Access Compliance Report Public Rights-of-Way (Curb Ramps)

Main Street: W_HARLE_AVE		Cross Street: S_BROOKHURST_ST		Location:	NE
ADA ID: RPAT220202140758	Ramp Type:Type 1 - Perpendicular	Initial Pass/Fail: Pass	Overall Compliance: No	Severity Score:	5
Codes/Mitigation Info/Possible Solution			Field Measurements/Component Compliance

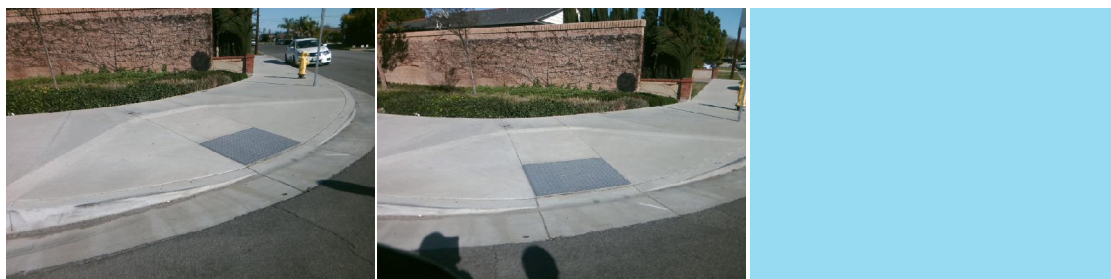
N/A	Ramp Inside Crosswalk 1	N/A	Yes	Ramp Inside Crosswalk 2	N/A
	Crossing 1 Slope (%)	4.2		Crossing 2 Slope (%)	N/A
	Crossing 1 Cross Slope (%)	1.5		Crossing 2 Cross Slope (%)	N/A
Yes	Gutter Ponding	No	No	Curb Slope	7.1
Yes	Gutter Lip Height (in)	0		Road Run Slope (%)	N/A
No	Gutter Run Slope (%)	5.1		Road Cross Slope (%)	N/A
Yes	Gutter Cross Slope (%)	0.4			
Yes	Overall Surface Condition: Acceptable		Yes	Perp Joint Present	Yes
	Cross Gutter Present?	No		Spandrel Present?	No
	Replace Cross Gutter?	N/A		Replace Spandrel?	N/A

Remove & Replace Curb Slope. Remove & Replace Gutter.
